Additional Traffic and Access Report

18 October, 2013

**RE: PART 3A APPLICATIONS FOR PROPOSED NEPEAN GREEN AND
MASTERS MIXED USE DEVELOPMENT, 164 STATION STREET, PENRITH**

19m ARTICULATED TRUCK SWEPT PATHS

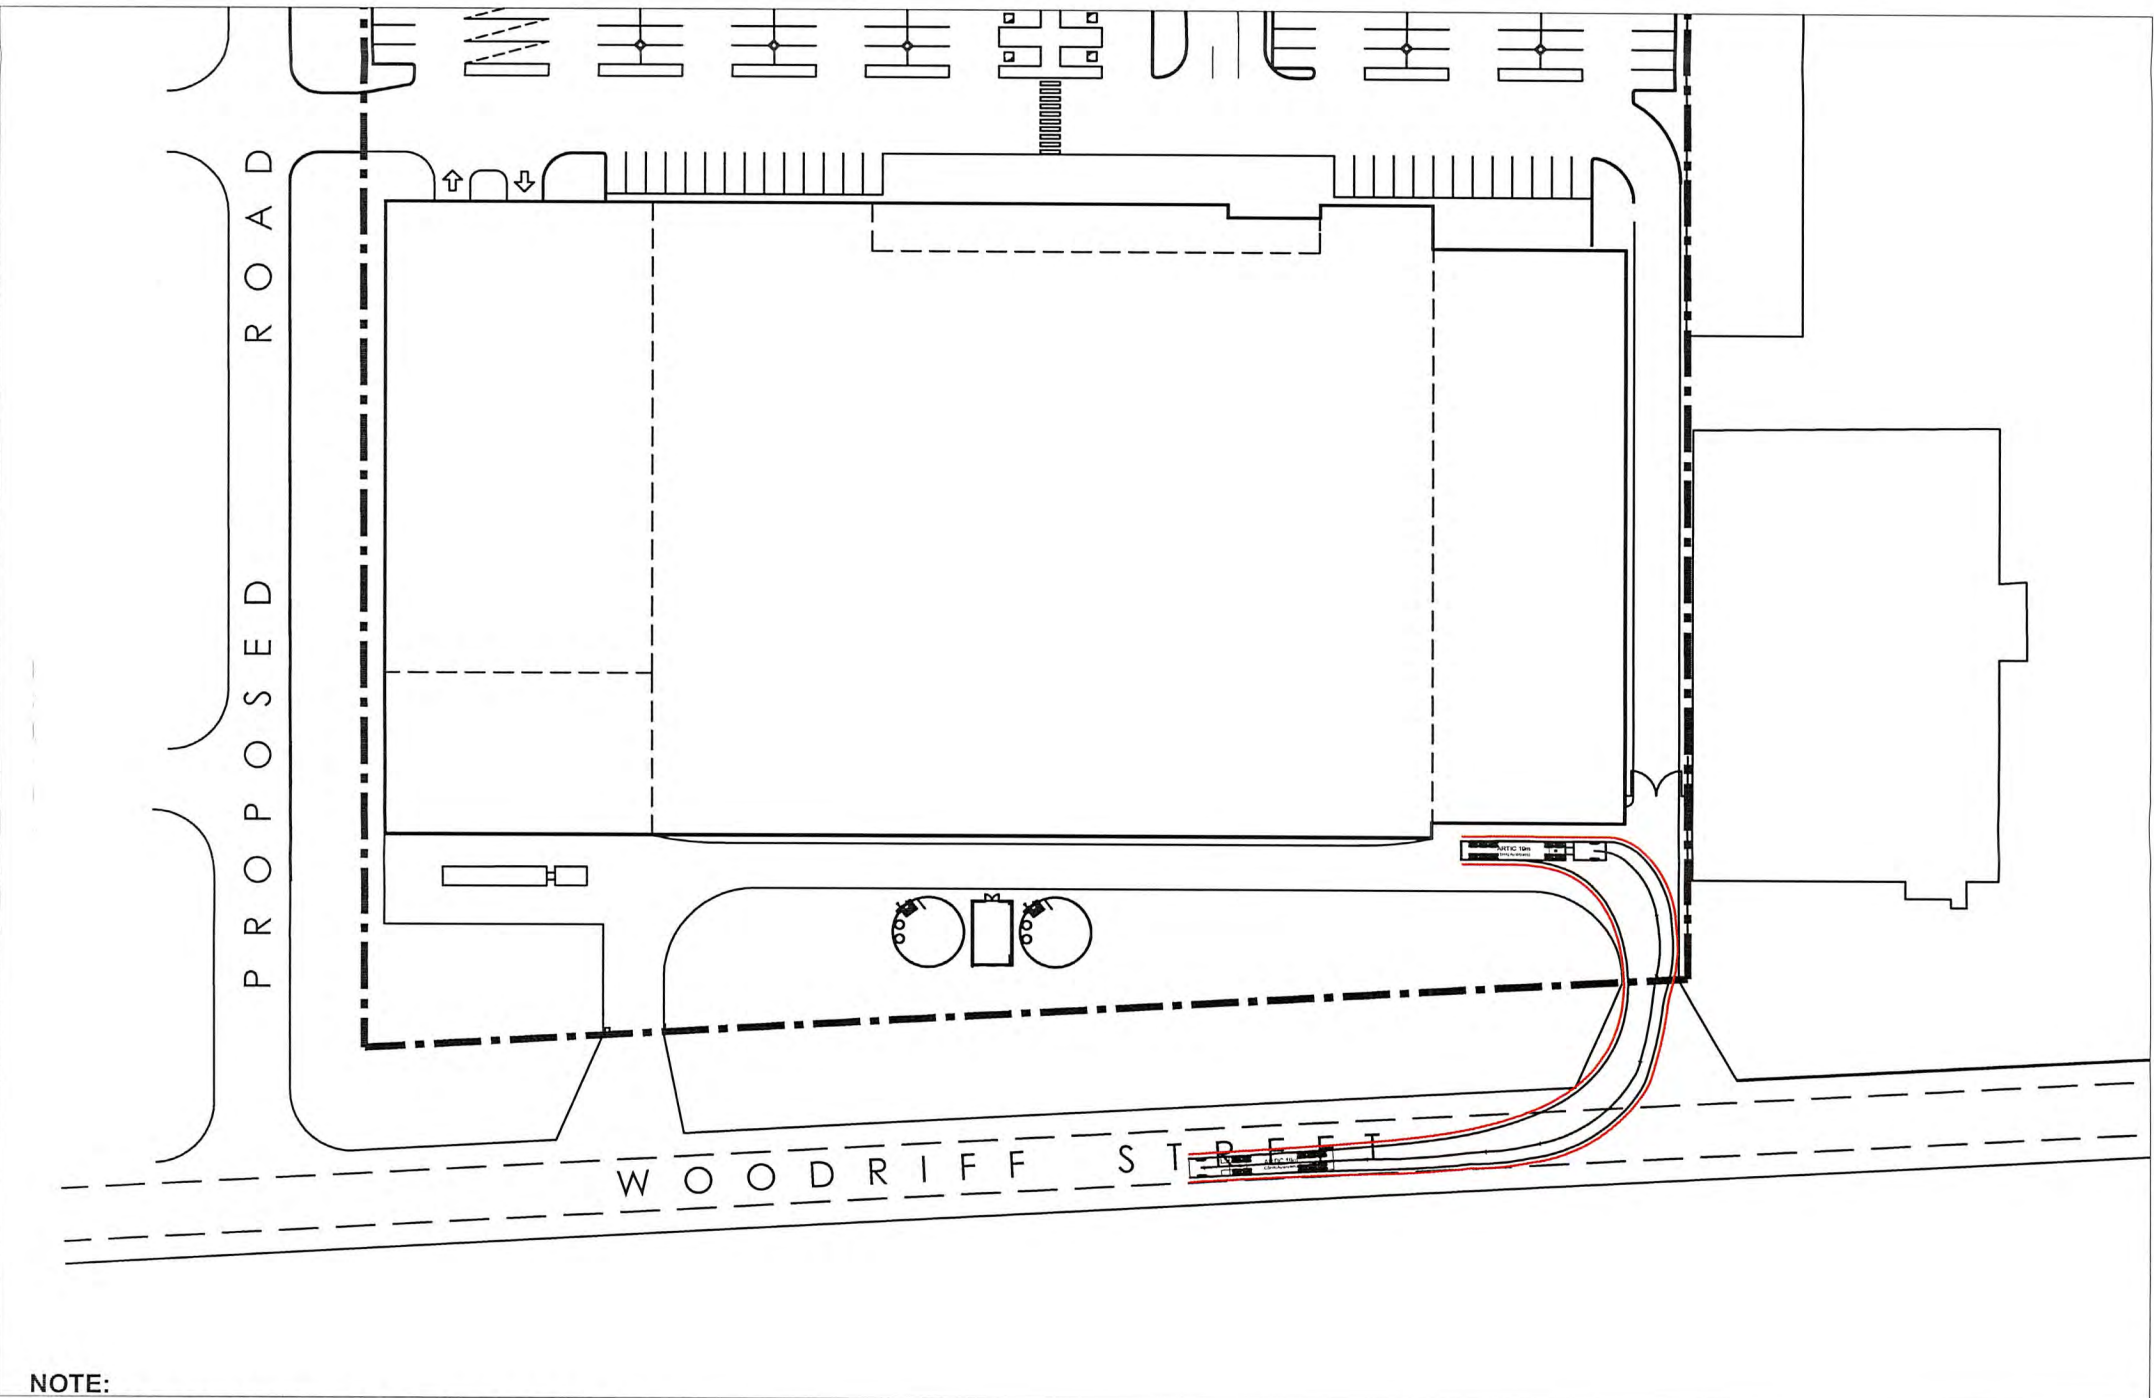
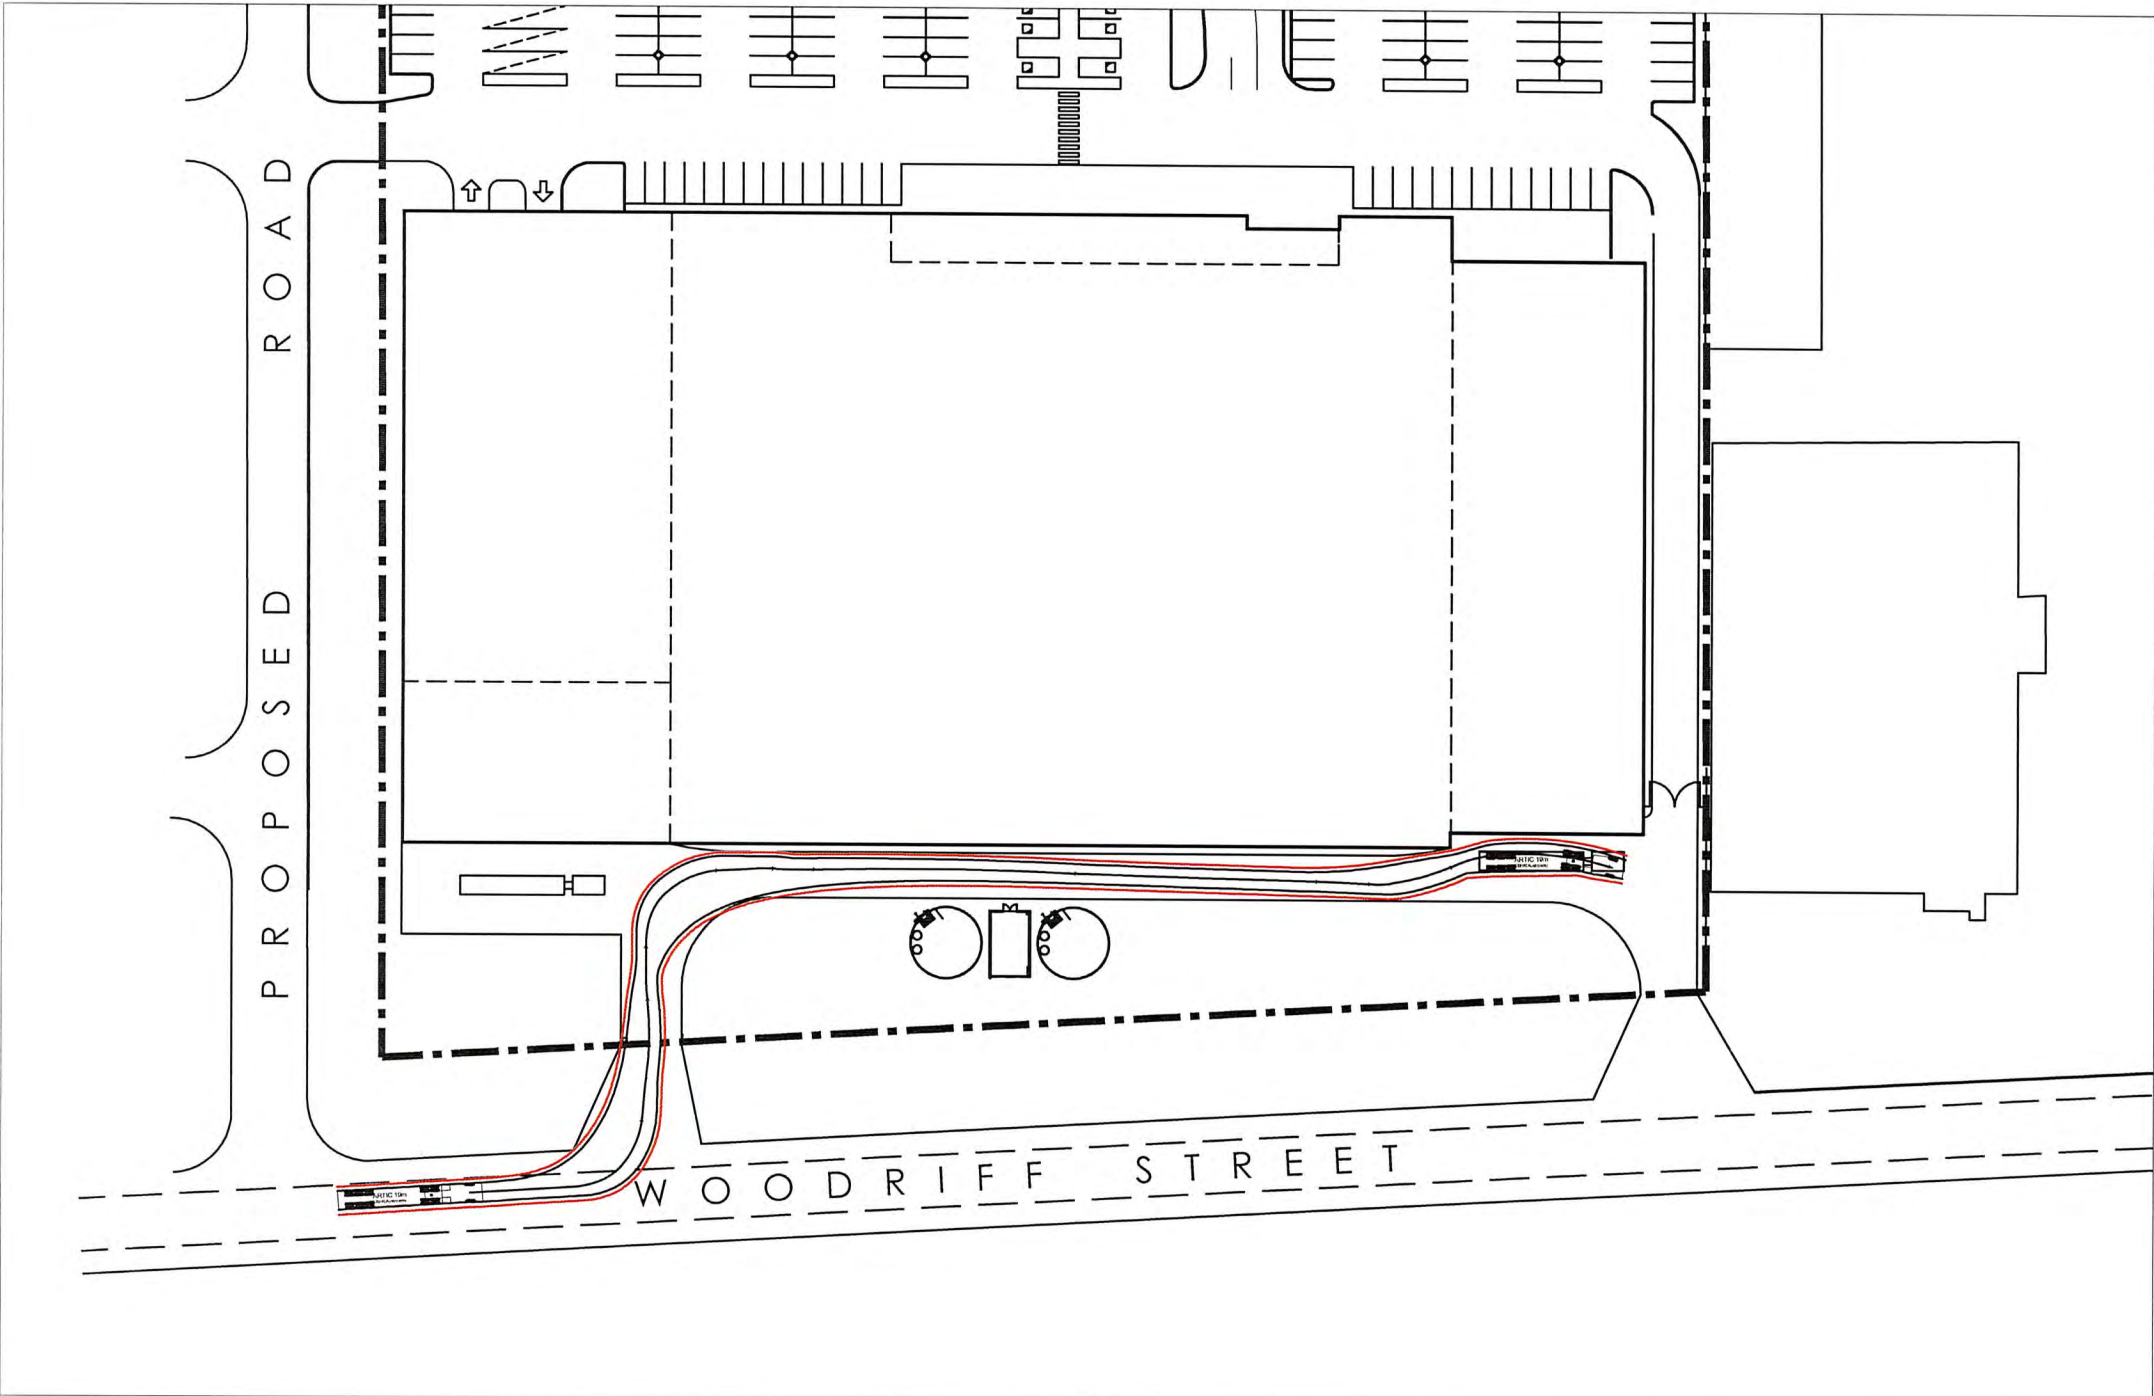
- a) *Swept paths have not been shown for the reverse loading movements on the southern side of the loading area (adjacent to the new central access road and to the rear of the trade centre).*

- b) *The reverse movement on the northern side of the loading area appears to show vehicles encroaching outside the gate at the exit driveway, to enable reversing into the loading dock. Clarification is required as to whether this will occur, and whether this reversing movement will result in any safety issues for pedestrians in Woodriff Street which needs to be addressed.*

30. The loading area on the eastern side of the Masters store has been amended. Swept paths are attached to this letter as Figures 4 and 5.
- c) *The swept paths diagrams should show traffic lanes on Woodriff Street as well as the proposed road (the new street) to determine whether these turn movements encroach across the centrelines of the roads.*
Parking restrictions may be required along Woodriff Street, on either side of the driveway access points, to cater for the swept paths of longer vehicles turning into and out of the site, so as to avoid them crossing the Woodriff Street centreline. Also, right-turn in and left-turn in movements off Woodriff Street appear to cross over the centreline area of the proposed road (the new street), which is undesirable and sub-standard for the main loading access point.

31. The amended loading dock for Masters provides for vehicles to enter and exit on the left hand side of the road, as shown in Figures 4 and 5.
- d) *It is unclear how conflicts would be managed resulting from longer vehicles turning from Woodriff Street needing to wait for any vehicles exiting and turning out of the site and the proposed road.*
